August 7, 2020

RE: OBMS Rezoning Request – Final Submittals

MIDTOWN - DC4

DC 4 SCREEN WALL AND LANDSCAPING

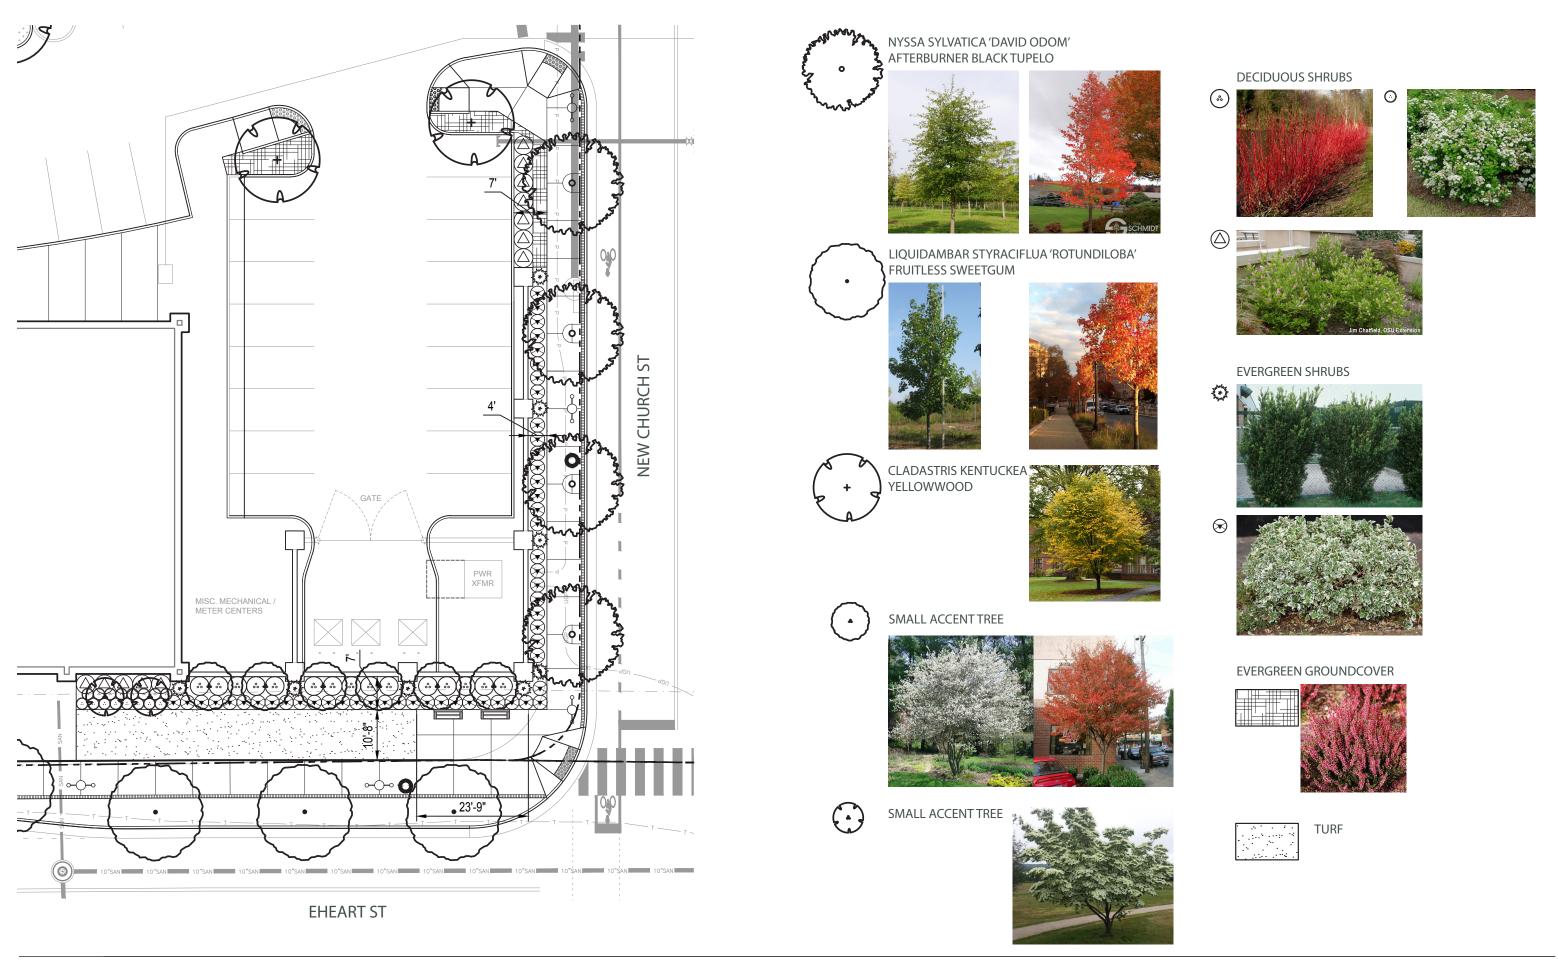
- The shrubs along the screening wall adjacent to Church Street have been revised to be an evergreen shrub instead of a deciduous shrub.
- The Sweetgum trees that were specified along DC 4 have been replaced with a non-fruit producing tree per Town staff recommendation.

THE COMMONS LOOP ROAD

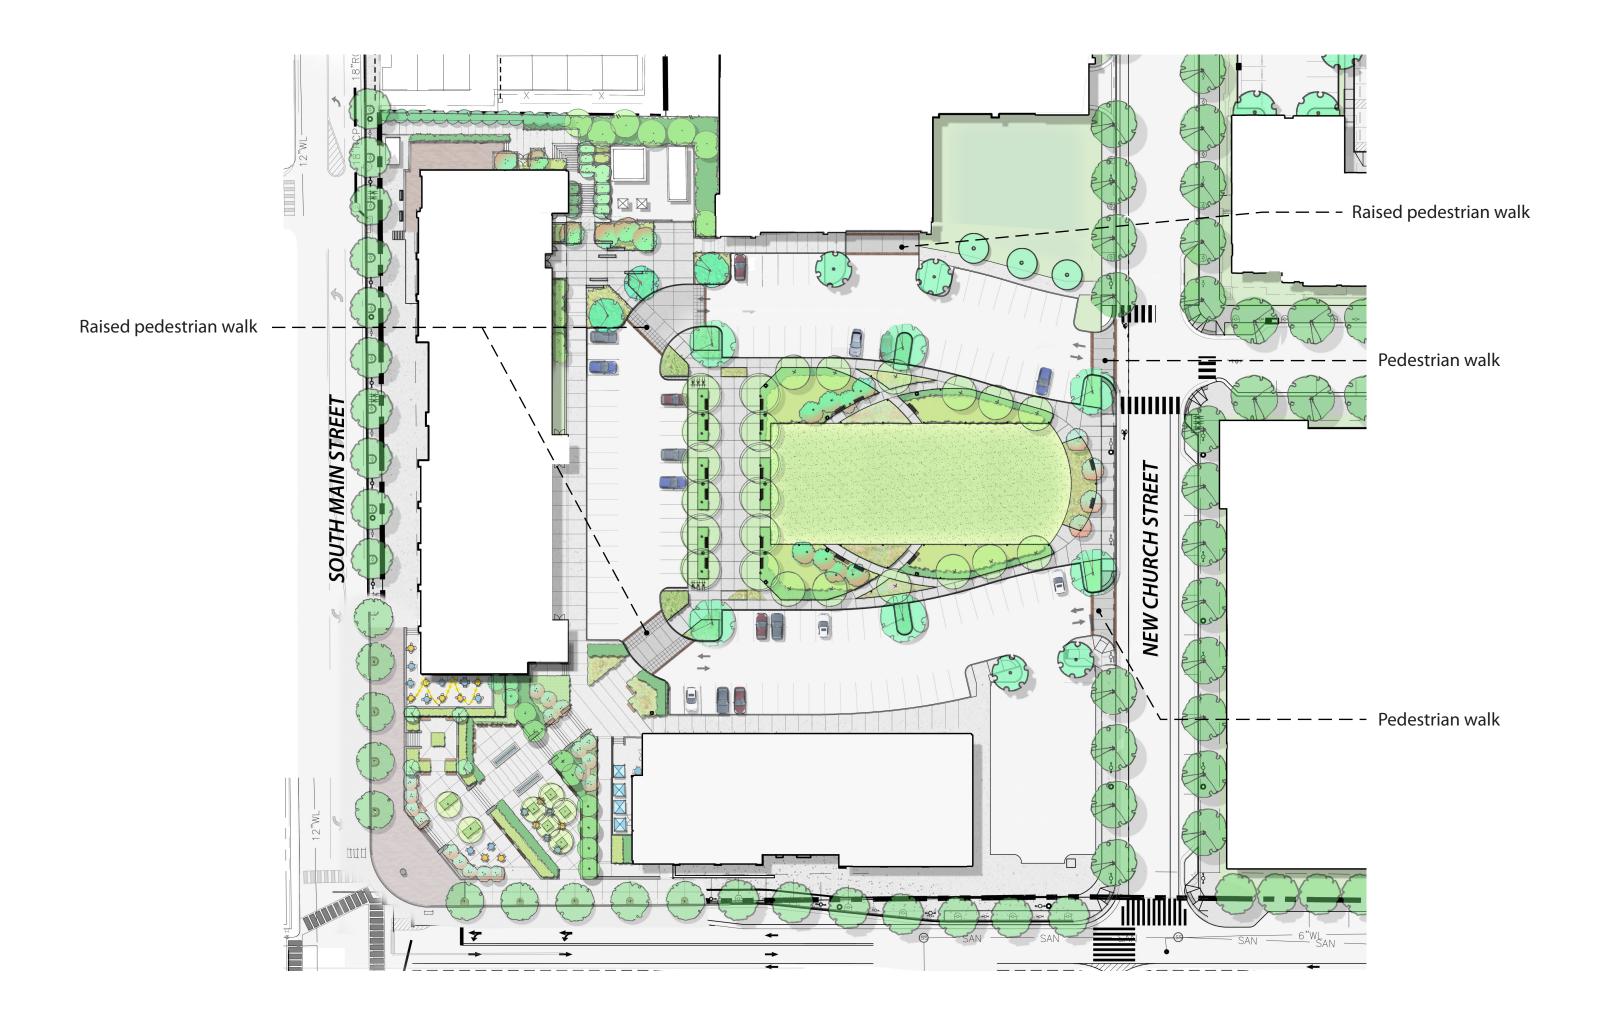
Midtown plans to provide five pedestrian walk areas along the loop road of which three will be raised as shown in the revised masterplan and the attached drawing. This will provide for a pedestrian accentuated crossing and also slow traffic around the Commons. Midtown is not specifying as part of the rezoning request what the exact material of those pedestrian walks will be, however they are committed to constructing them out of an alternative material rather than asphalt. Those materials could include concrete, brick, pavers, stamped and/or colored concrete.
